STERLING HILLS FILING NO. 15 PRELIMINARY PLAT

A RESUBDIVISION OF LOT 1, BLOCK 1, STERLING HILLS SUBDIVISION FILING NO. 14 SITUATED IN THE SOUTHWEST ONE-QUARTER OF SECTION 27, TOWNSHIP 4 SOUTH, RANGE 66 WEST OF THE SIXTH PRINCIPAL MERIDIAN, CITY OF AURORA, COUNTY OF ARAPAHOE, STATE OF COLORADO

STERLING HILLS FILING NO.15 PRELIMINARY PLAT

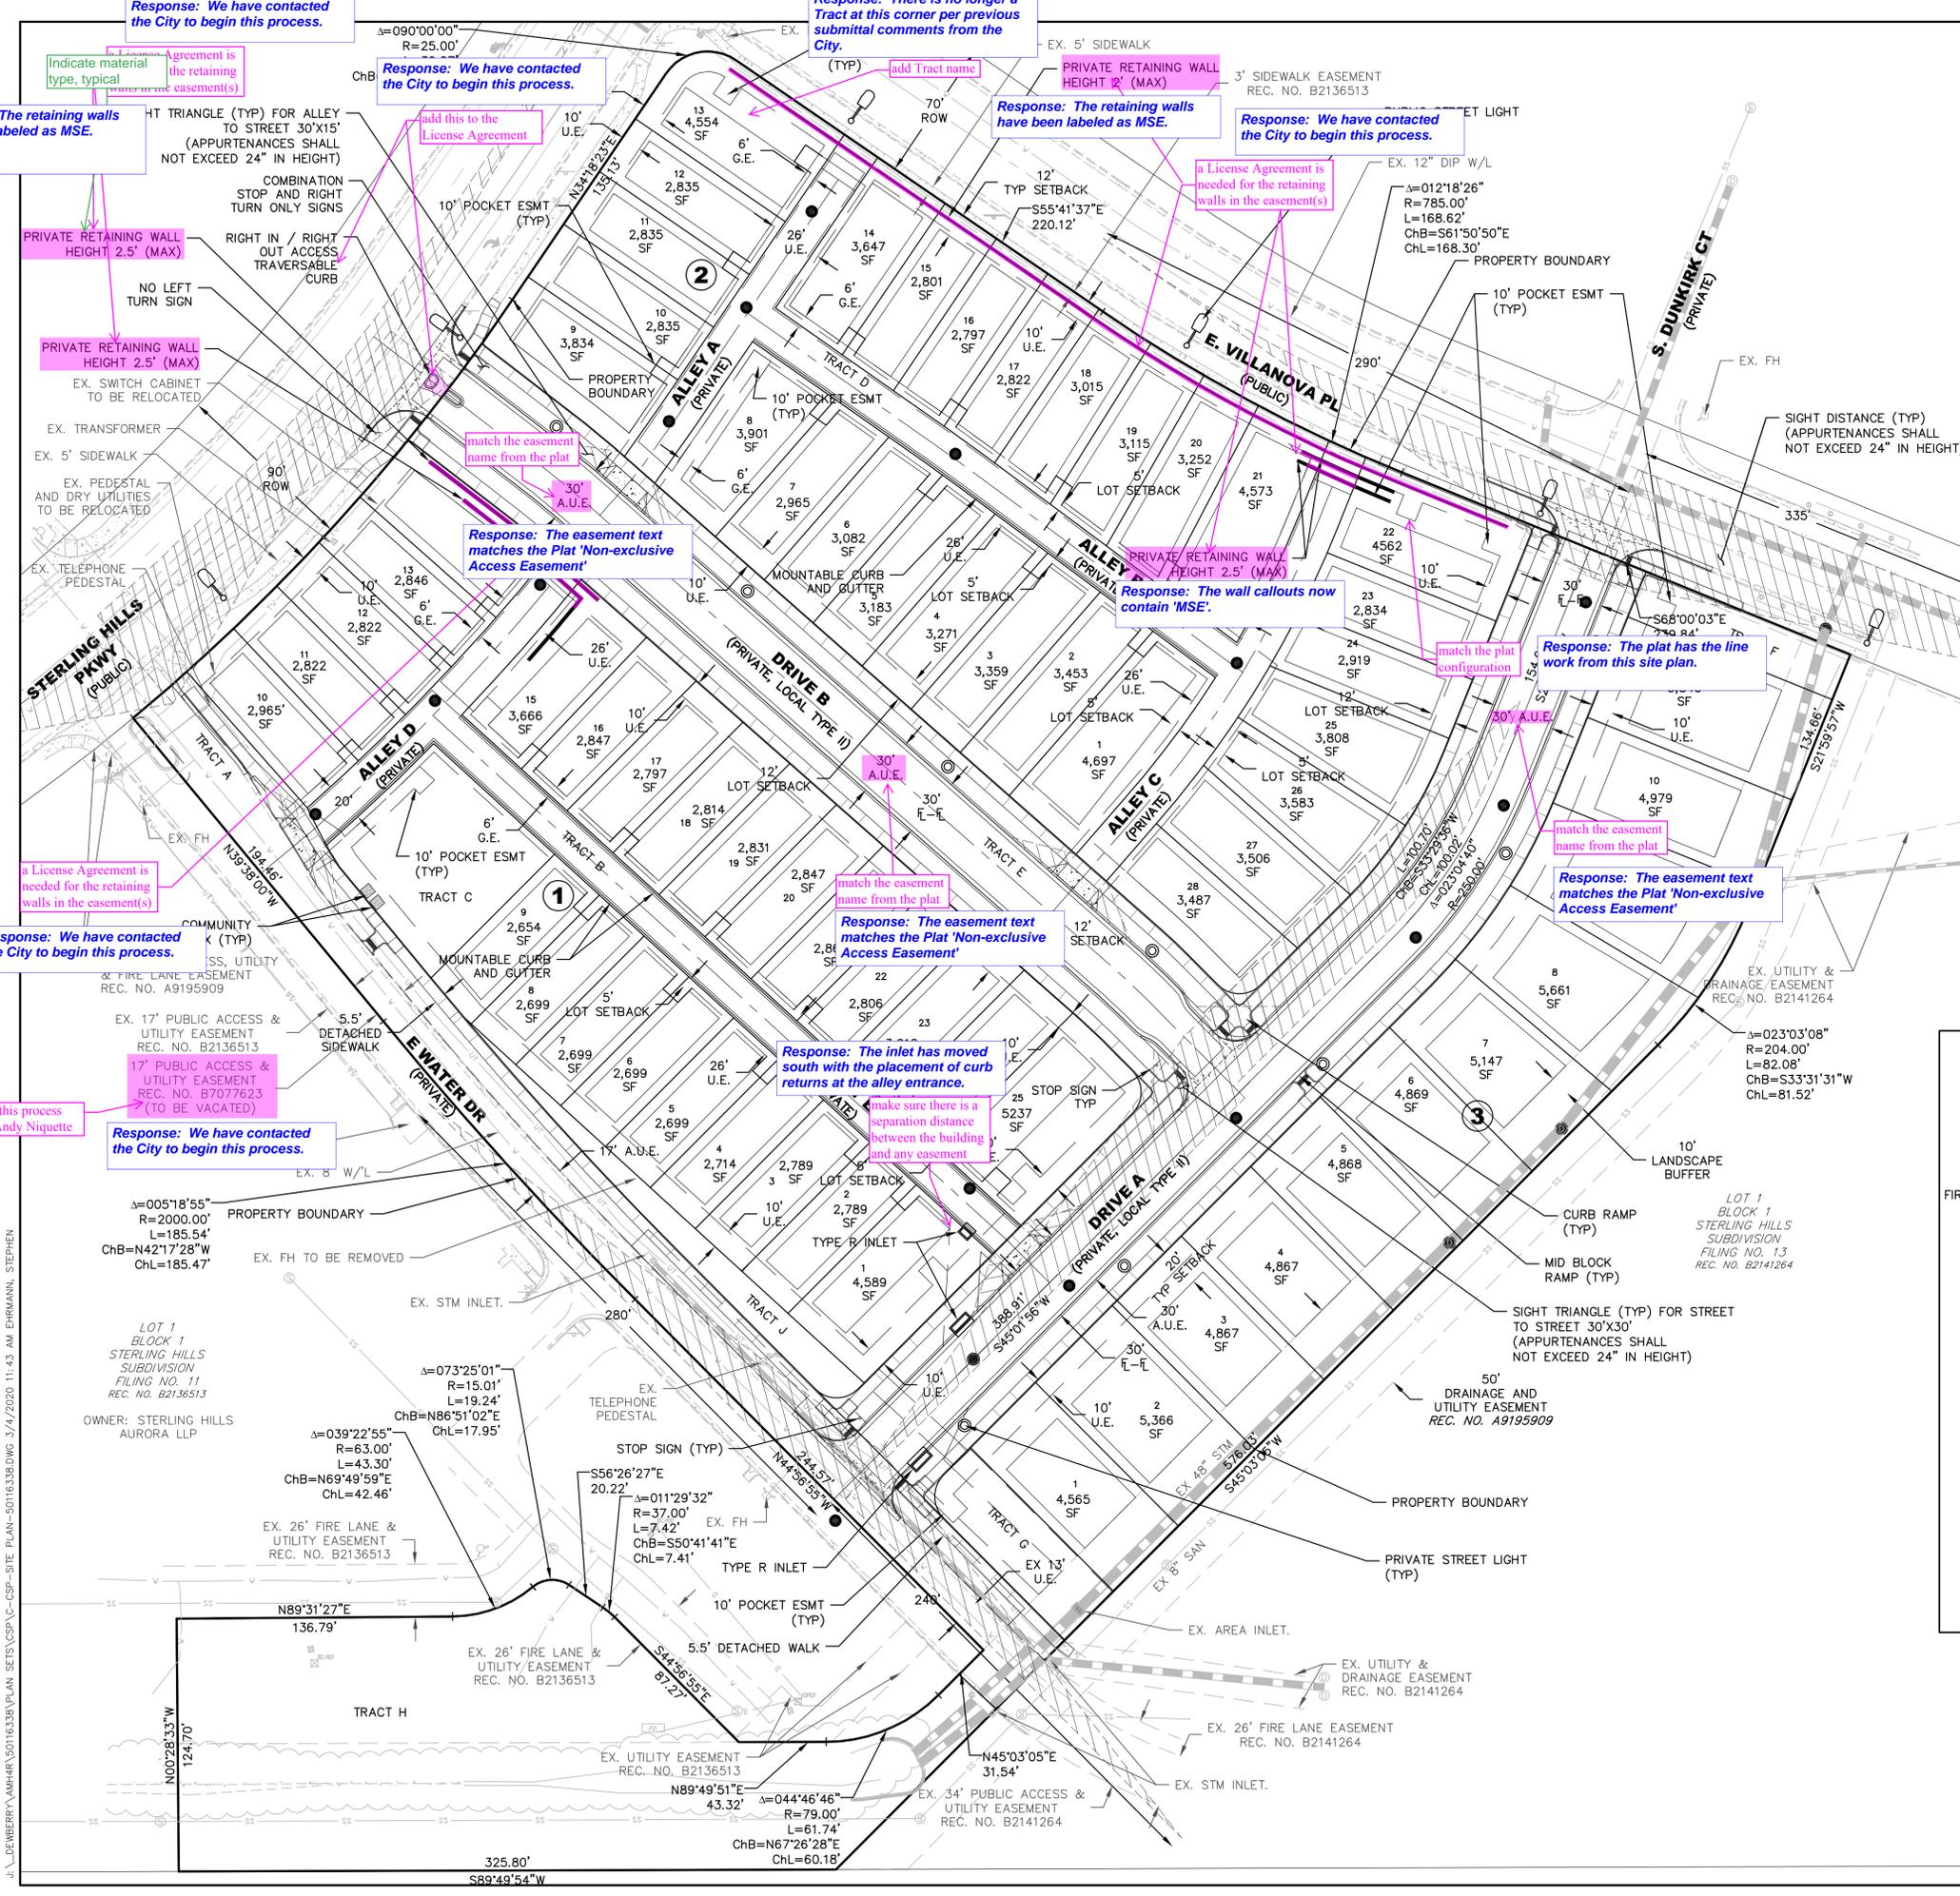
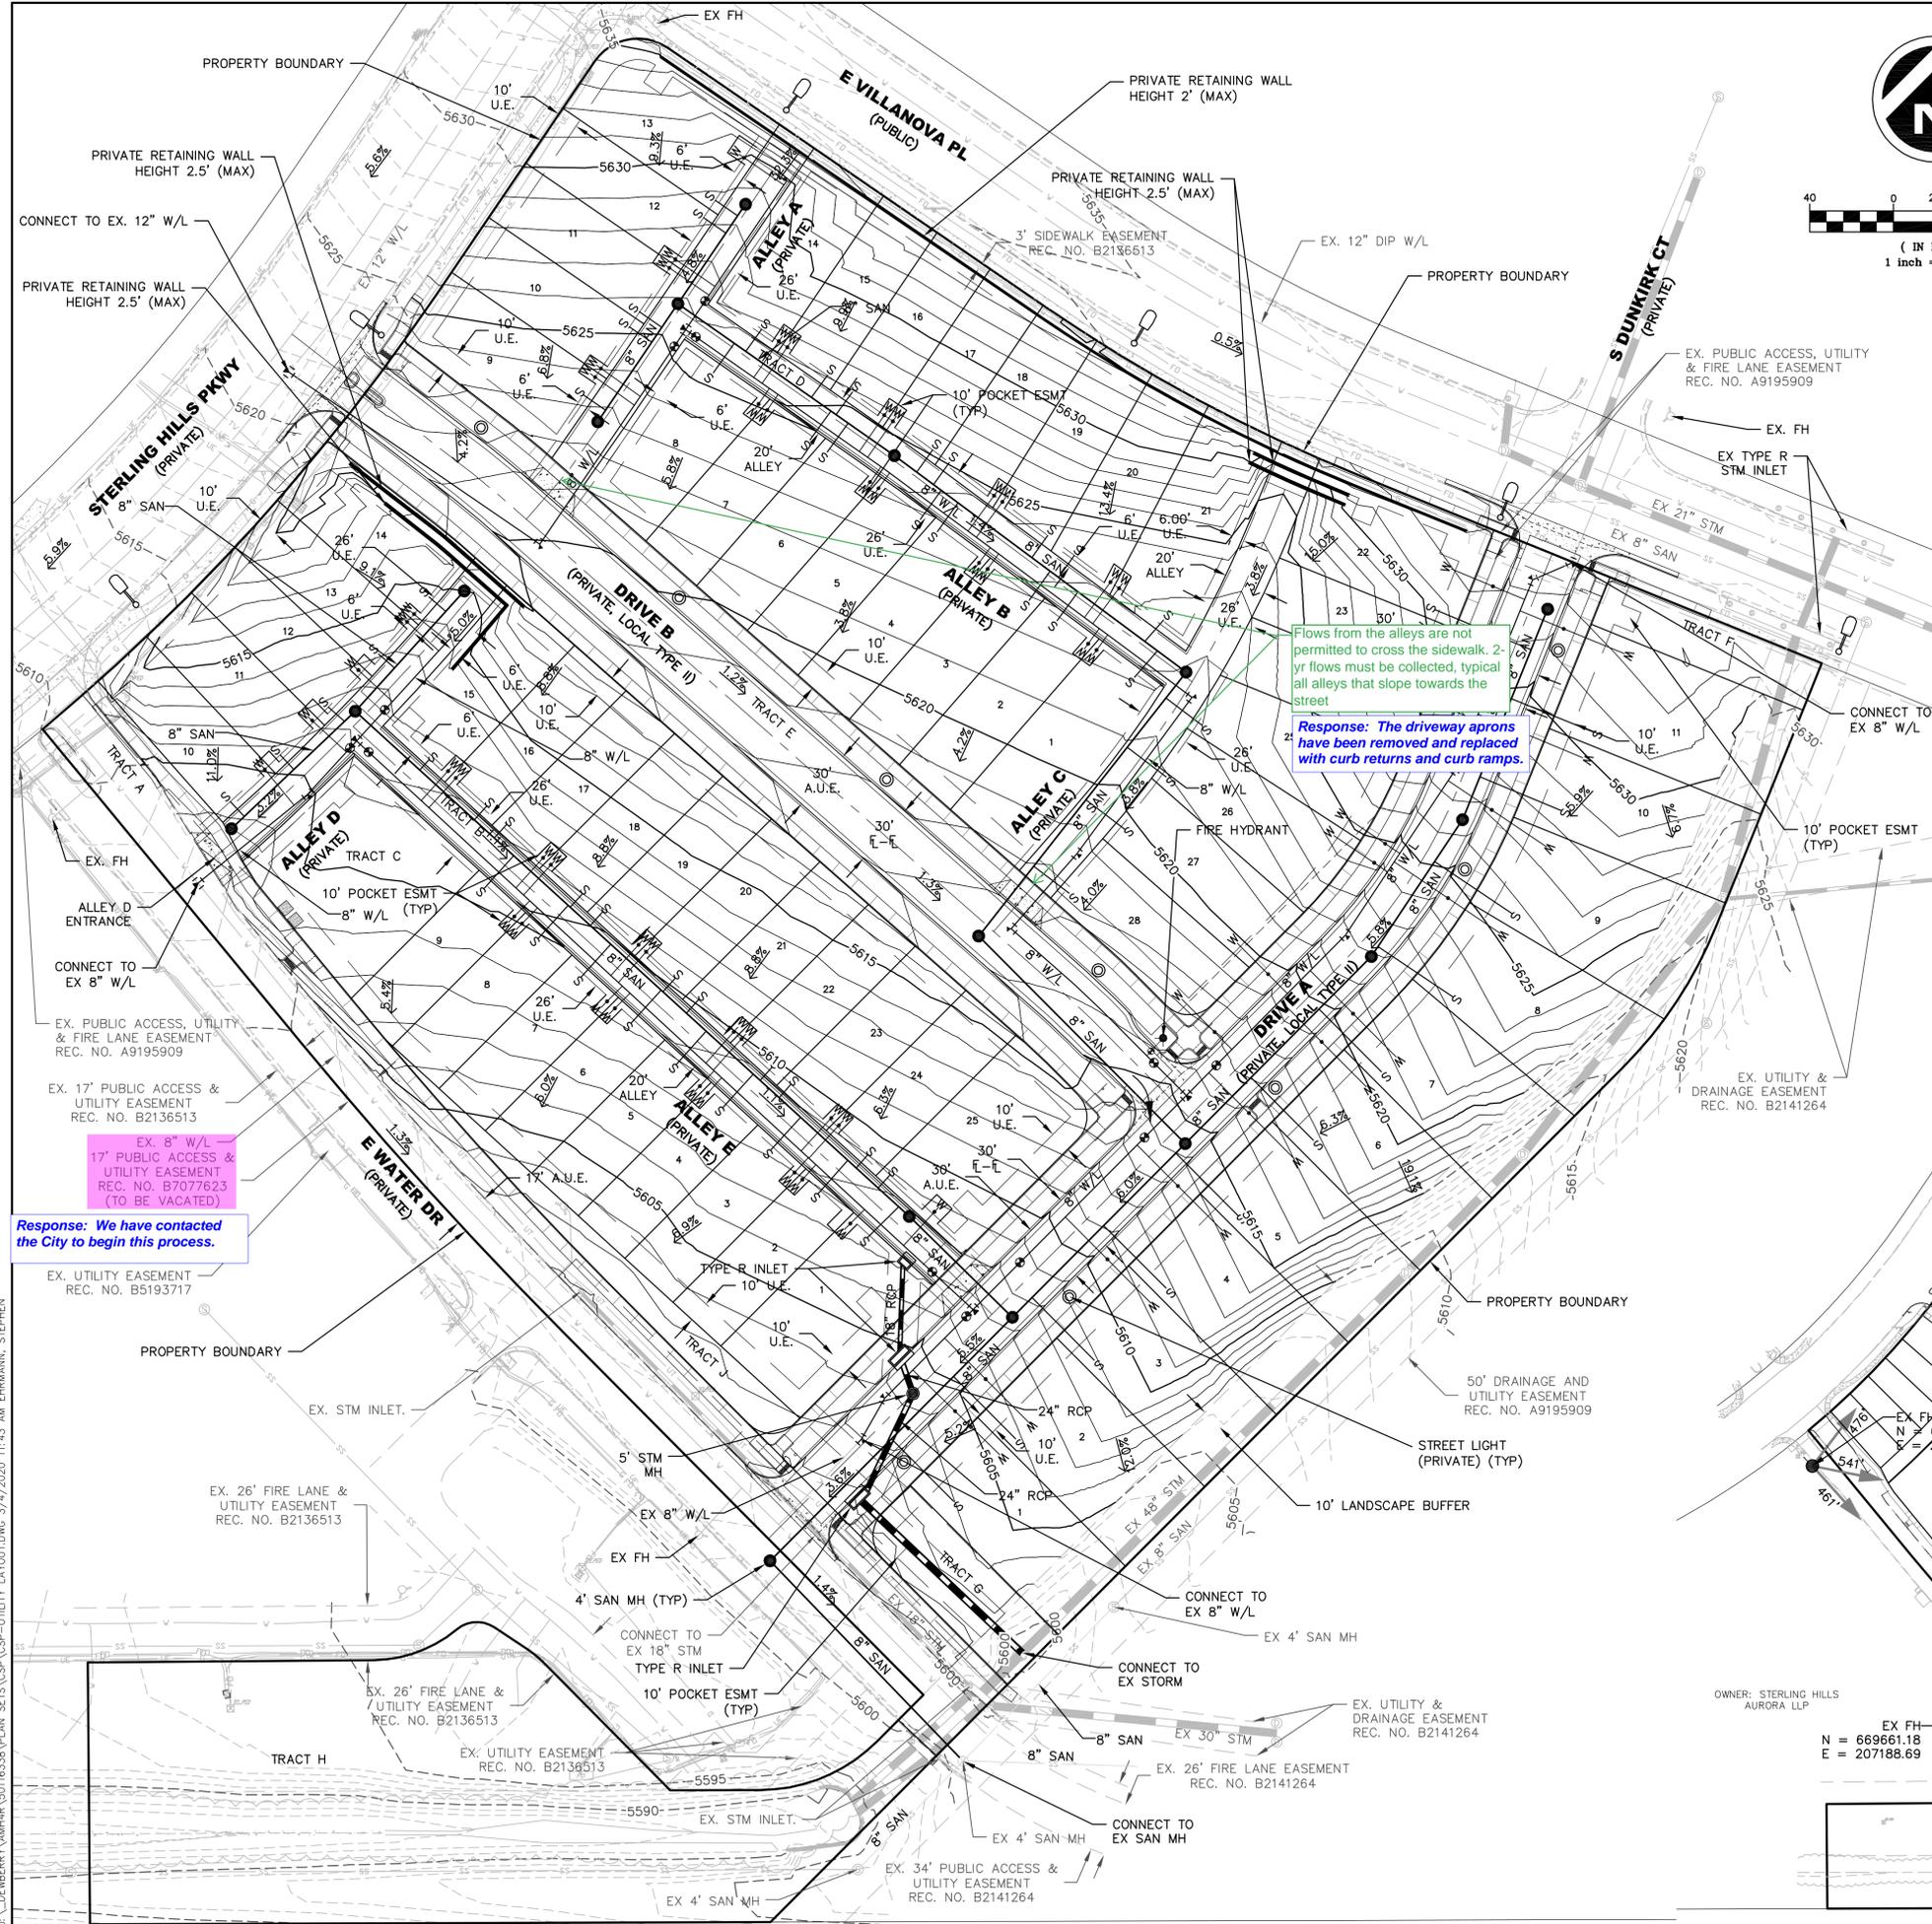
Flows from the alleys are not permitted to cross the sidewalk. 2 yr flows must be collected, typical all alleys that slope towards the street

Response: The driveway aprons have been removed and replaced with curb returns and curb ramps.
